Product Change Notice

Issue Date: September 23, 2019

Add SPIL Taiwan as Bump supplier

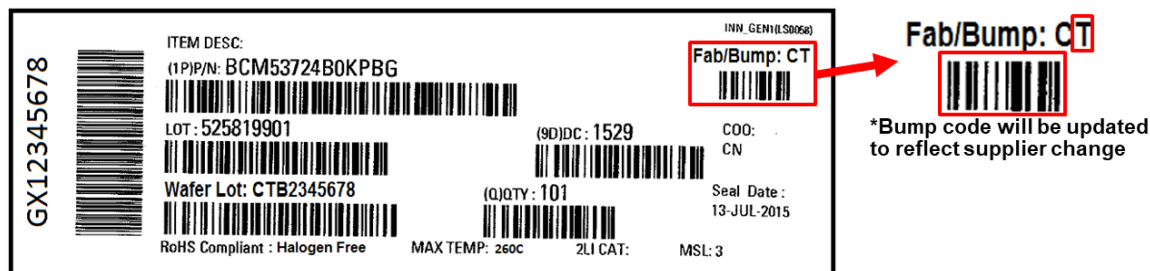
Additional CuP Bump supplier - SPIL TAIWAN

- Adding bump supplier. Broadcom reserves the right to manage supplier.
- The construction of the bump is identical
- SPIL Taiwan has internally qualified the direct CuP bumping and in volume production.
